DYNAMIC SWEATER IND. LTD

10, Ganda, Savar, Dhaka
(23.827699N, 90.260594E)

1st November 2015

Observations

Poor construction quality of the RC elements observed

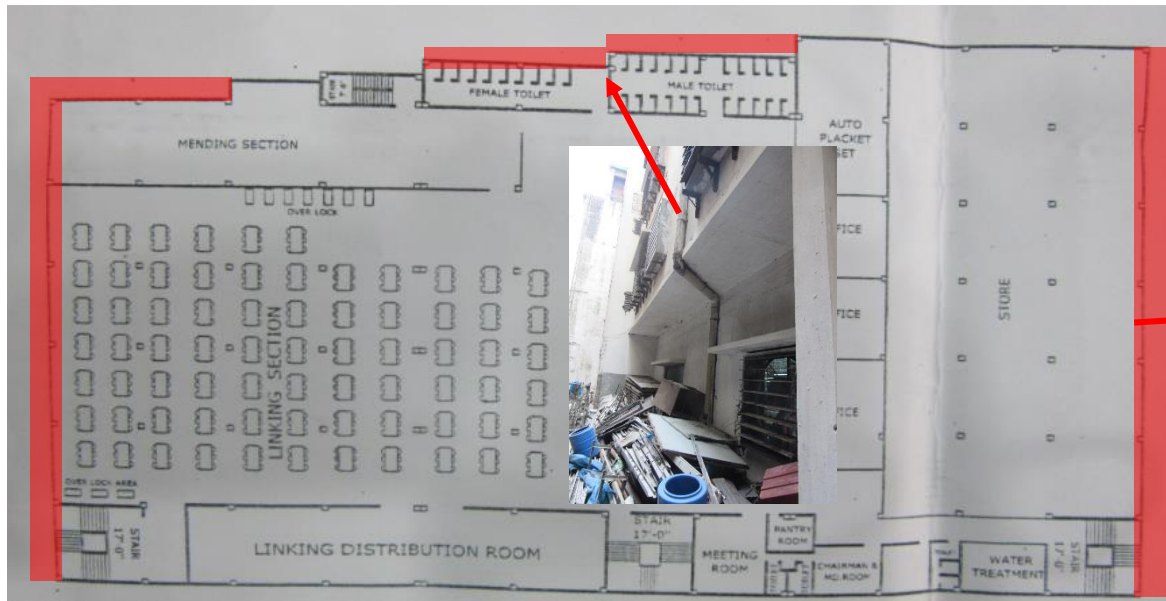
Uneven slab due to bad formwork

Insufficiently compacted concrete

Uneven slab due to bad formwork

Additional cantilevers

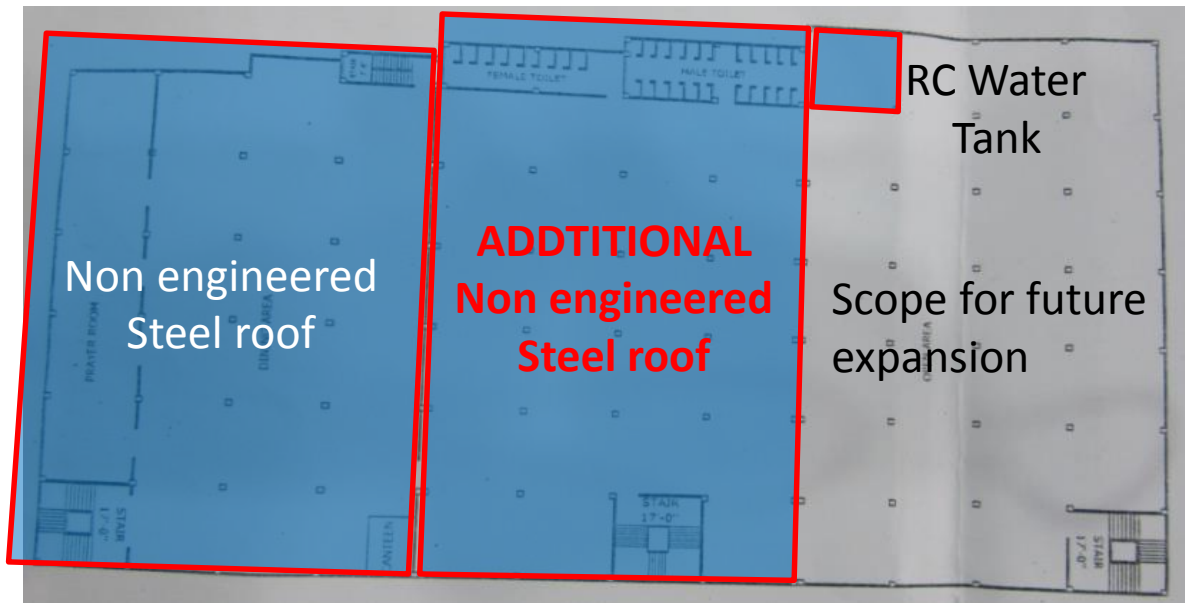
Discrepancy between Permit Drawings and Site observations

(additional cantilevers, additional level on
the roof, apparent scope for future
extension observed)

**Wet surface, leakages on the walls below
water tanks**

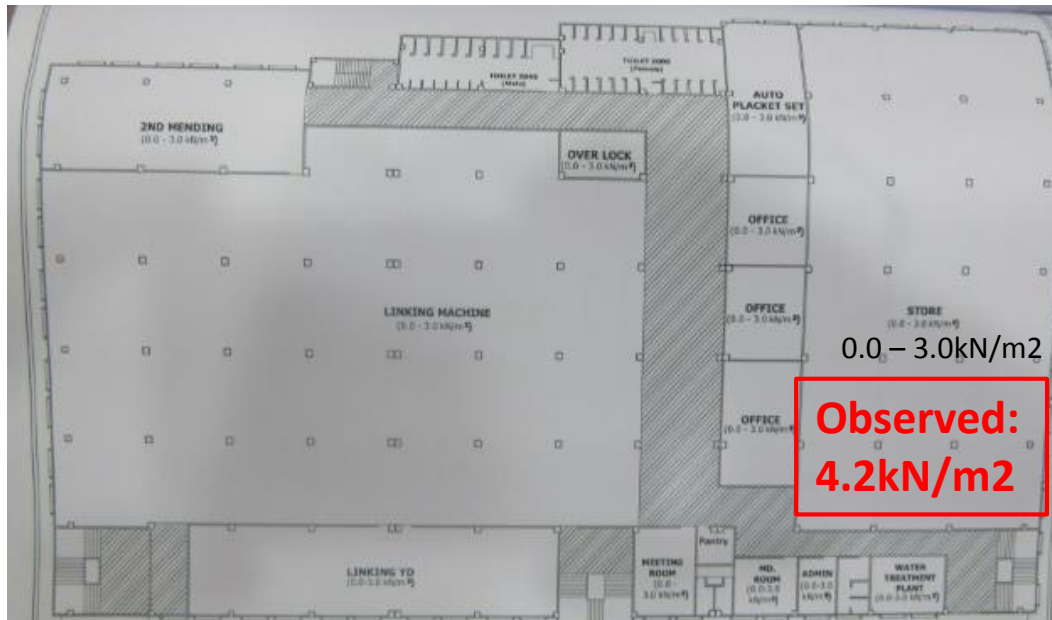
Standing water on the roof

Wet surfaces underneath the water tanks

Non-engineered roof structure

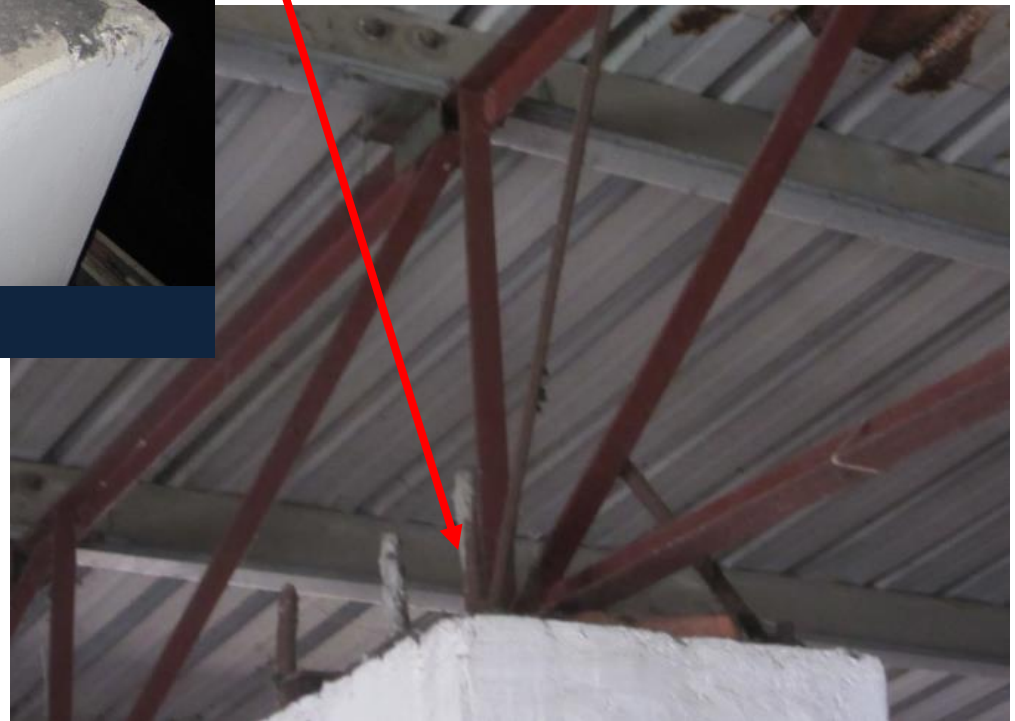
(Twisted purlins, lack of bracing, weak support details)

Lack of bracing in roof structure

Non-engineered connections

Lack of anchors
